BEFORE THE PUBLIC UTILITIES COMMISSION
OF THE STATE OF CALIFORNIA

R.11-09-011
Filed September 22, 2011

CLEAN COALITION'S REPLY COMMENTS ON JUNE 21 2013 WORKSHOP ON
SMART INVERTER FUNCTIONALITIES AND RECOMMENDATIONS FOR
UPDATING TECHNICAL REQUIREMENTS IN RULE 21

Power circle showing inverter P (real), Q (reactive), S (complex) power output capability. Note the large range of reactive power output at a 0.9 Power Factor (shown in this example with 10% inverter headroom relative to real power output).

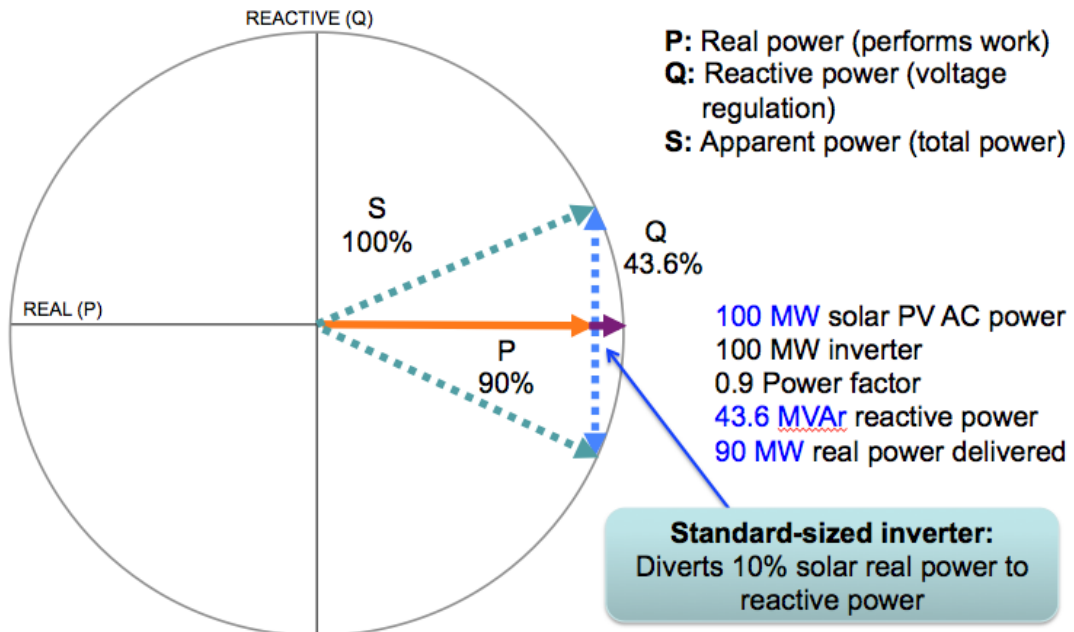
We wish to clarify in consultation with other parties that the Clean Coalition recommends a +/- 0.1 variability in the required average power factor range, resulting in a power factor (PF) of +/- 0.9, as this results in the most efficient provisioning of reactive power, allowing 45% of the maximum possible VAR output with no more than a 10% relative use of real power or reduction of output during periods of generation. We do not object to the ability to adjust PF further, and allowing a PF of +/- 0.7 will provide moderately greater VAR provisioning capacity during periods of critical need, however there are potential higher equipment costs and rapidly diminishing returns and increased impact on metered real power output as the PF is adjusted across a greater range. It would be both inefficient to incur costs not commensurate with value, and inappropriate to require system owners to do so if not compensated in some manner.

This is demonstrated in the following figure illustrating the relative reactive power (VAR) output and real power required at a 0.9 PF and how this would change with lower settings, and a graph of the change in economic value of reactive power production as the PF is reduced; in this example, taken from the above referenced report, the net value of reactive power production is positive only above a PF of 0.9.

PV Intermittency Mitigation Based Upon Modeling with Smart Inverters

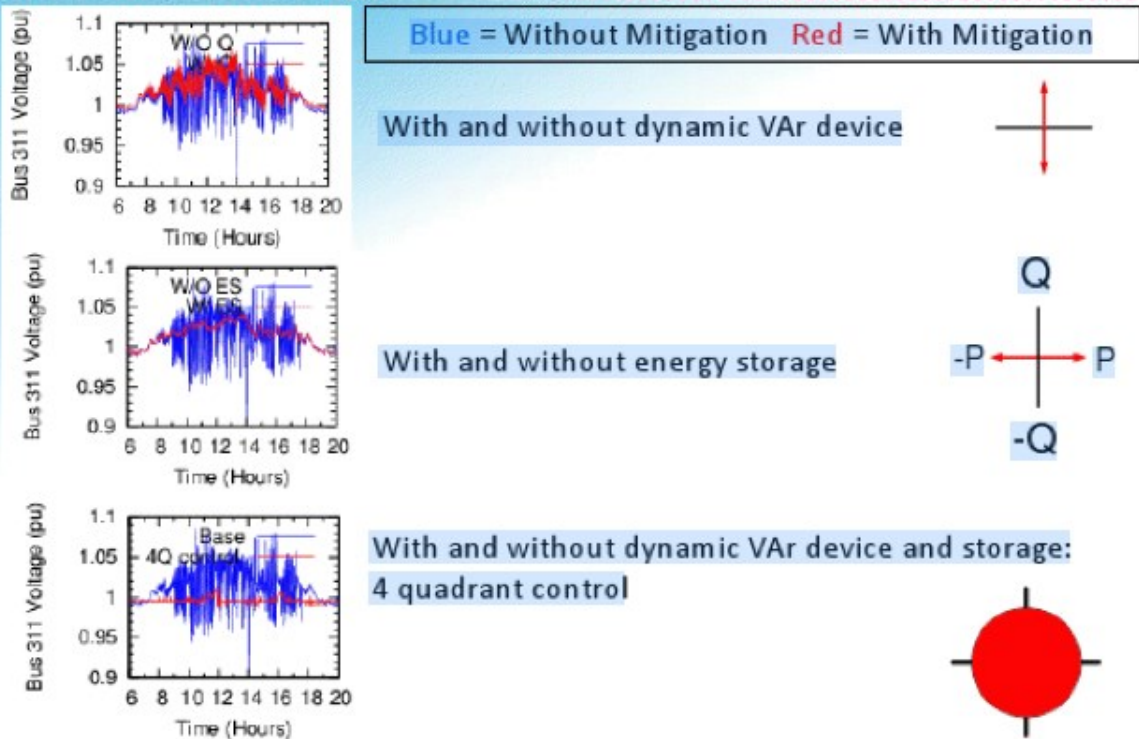
The following graphic³ illustrates the opportunity for advanced inverters both alone and combined with storage to address voltage variation and make the grid reliable with high penetration DG. This graphic separates the effects of the real power (P) & reactive power (Q) components of advanced inverters:

- The 1st example is pure +/- Q, which definitely reduces the range, but cannot always shave off the excessive peaks that exceed the 5% upper limit because a pure reactive load does not move the real voltage down that much.
- The 2nd example is pure +/- P from the energy storage with the inverter fixed to a power factor of 1.0 (no reactive power); it definitely narrows the range since the battery can now add load to that node to help lower the peaks, but there is still quite a bit of variability.
- The 3rd example with the full ranges of P & Q available (all 4 quadrants of the circle) does an amazing job of controlling the voltage.
